**Manuscript ID:** egusphere-2024-2525

**Original Title:** *Improving prediction of particle size with a novel acoustic bedload monitoring system consisting of phased microphone arrays and accelerometer*

**Authors:** Zheng Chen et al.

### **Responses to the Comments from Reviewer #2**

Figure 6 in *Wyss et al. (2016a)*. Maximum amplitude of a packet  $A_{max,p}$  as a function of mean particle-size  $D_m$ , for different mean flow velocities  $V_w$

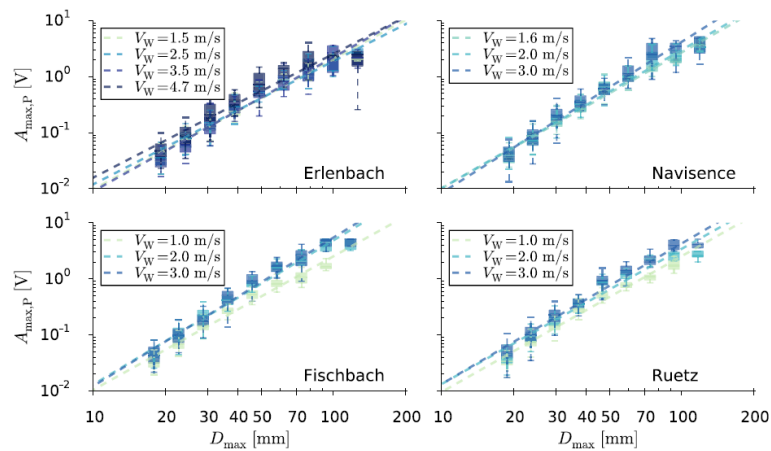
I see a main unknown and potential flaw in the design to relate impact amplitudes with grain size while keeping the drop height for each particle somewhat constant. It is hard for me to imagine how under natural conditions there will be constant drop heights for particles of varying size. Or, the other way around, how would the approach successfully estimate the correct grain size if river bed particles hit the instrument with different fall velocities and overall differing horizontal velocity vectors? What about those particles that rather slide and roll instead of jumping? These fundamental questions are neither raised nor implicitly addressed by the study, neither in the experiment design nor in the argumentation.

In writing “somewhat constant” in the above paragraph, I wonder why the height of centre of mass of the particles above the plate was kept constant instead of keeping the full vertical drop height constant. This adds a further unnecessary (or unexplained) variable that changes the experiment results.

Second, we have indeed explored the role of impact velocity in our experiments. Although impact velocity does affect the signal amplitude, our laboratory tests show that its influence is less significant than that of particle size. Similar conclusions were reported by *Wyss et al. (2016a, WRR)*, who demonstrated that increases in flow velocity (and thus increasing particle impact velocity) led to only modest increases in signal amplitude of the SPG system across particle sizes (see Figure 6 from *Wyss et al. (2016a)*, attached below for reference).

In our experiments, we controlled the **drop height based on the particle's center of mass**, resulting in slightly different release heights for particles of different sizes. This design choice was not intended to mimic any specific natural condition, but rather to ensure consistency with previous laboratory calibration studies of SPG systems (*Chen et al.*, 2022, JHR), allowing meaningful comparisons to be made across technologies. Moreover, under a fixed center-of-mass drop height, smaller particles do indeed reach slightly higher impact velocities than larger particles. This matches the common trend observed in natural settings whereby smaller bedload particles tend to move faster than larger ones under the same flow and bedload slope conditions. We have added a note to the manuscript to clarify this point.

Figure 12 in Wyss *et al.*, (2016, JHE).  $z_p$  ratio of the left and the right central geophone plates ( $gp_{left}$  and  $gp_{right}$ ) as a function of unit bed load transport rate

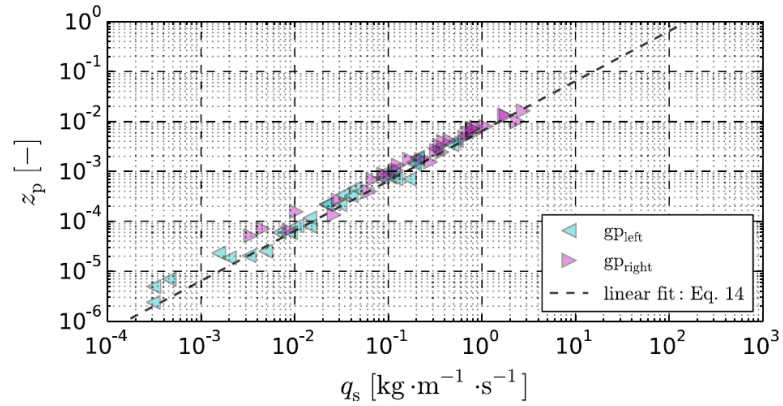
Another, major flaw arises from the inability to locate and quantify the effects of multiple particles being in contact with the plate. As nice as it is to isolate single impacts, under natural conditions the norm will be to experience multiple impacts during a bedload transport period, even during the time window for which the first pulse of an impact signal is collected. If it is impossible to reliably locate two or more sources at a time, it will also be impossible to extract reliable information on the particle size and hence the envisioned total bedload flux across the sensor plate. I might have missed some detail in reading the manuscript but from the results section (e.g. Fig. 7) it seems that the two synchronous impacts cannot be deciphered, as one would expect from the capabilities of a phased array setup, and as is discussed in the manuscript further down.

We acknowledge the reviewer's concern regarding the possible occurrence of *multiple simultaneous impacts under natural conditions*. Previous work by Wyss *et al.* (2016, JHE) quantified the probability of overlapping impact signals using the time ratio  $z_p$ . Their analysis (Fig. 12, also presented below for reference) showed that for transport rates  $q_s$  smaller than  $\sim 5$  kg/s/m,  $z_p$  values are typically below 1, indicating that simultaneous impacts are unlikely and single-particle signals can be reliably isolated. Only for intensive transport rates, such as those exceeding  $\sim 100$  kg/s/m reported for the Erlenbach site (Hegg and Rickenmann, 1999), the value of  $z_p$  is expected to be close to 1, in which case the number of identified packets from the geophone signal may not deliver accurate measurements.

Figure 4(d) in the main text. Illustration of the first wave of the microphone signal.

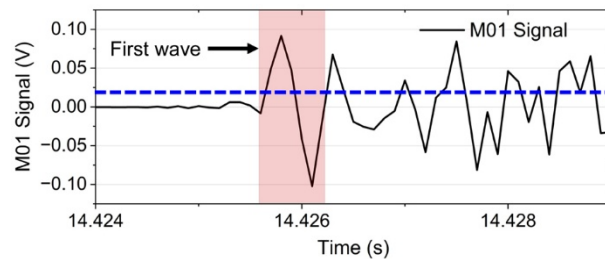
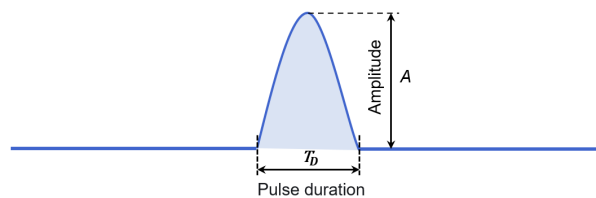
We hope this revised presentation better contextualizes the design rationale without overloading the section with technical derivations.
- **Specific comment 13:** **Response:** I. 213, why a sine wave and not the more likely to expect pulse signal? Can you explain/justify this? Will this decision not affect the validity of the test outputs with respect to the envisioned natural settings?

We appreciate the reviewer’s thoughtful question regarding the choice of input waveform in the numerical tests. The use of a periodic cosine (or sine) wave was a deliberate decision based on both practical and physical considerations.

First, from a modeling standpoint, a periodic sine wave offers precise control over the signal frequency, which is crucial for evaluating the performance of the beamforming algorithm under varying array configurations (e.g., sensor spacing, number of elements, and multi-source scenarios). This allows us to isolate the influence of array design on spatial localization accuracy in a controlled manner, independently of complex signal shapes or broadband spectra.

Second, the sine waveform is also physically justifiable. Impact-induced acoustic signals recorded in our laboratory experiments often exhibit an initial phase of high-frequency oscillation that closely resembles a few cycles of waveform. As shown in Fig. 4d, the impact-induced signals recorded by a microphone element in our laboratory display an initial phase of rapid oscillation lasting 1–3 ms. These oscillations result from the short-duration contact between the particle and plate and are affected by particle size, contact stiffness, and impact dynamics. Similar behaviors have been reported in SPG system data and in finite element simulations (*Chen et al.*, 2022 <https://doi.org/10.1080/00221686.2022.2059585>), supporting the physical relevance of our waveform choice.

Furthermore, the half-sine pulse is widely recognized as a classical form of mechanical shock loading in standards such as IEC 60068-2-27. Our use of a short-duration periodic cosine wave can be seen as an idealized extension of this fundamental pulse type for the purpose of numerical analysis.

We agree that an impulse-type input could also be used in such simulations, and it may better reflect certain broadband aspects of real-world signals. However, we believe this difference in source waveform has limited impact on the key findings of this study, which primarily focus on the system's ability to localize and reconstruct acoustic sources using beamforming principles. Most importantly, the PMA system is not solely evaluated based on simulations—its performance is being validated through extensive physical tests, including controlled drop experiments and future flume and field applications, which will incorporate the full complexity of natural impact signals.

We have added clarification to this point in the revised manuscript (see Sect. 2.4.3).
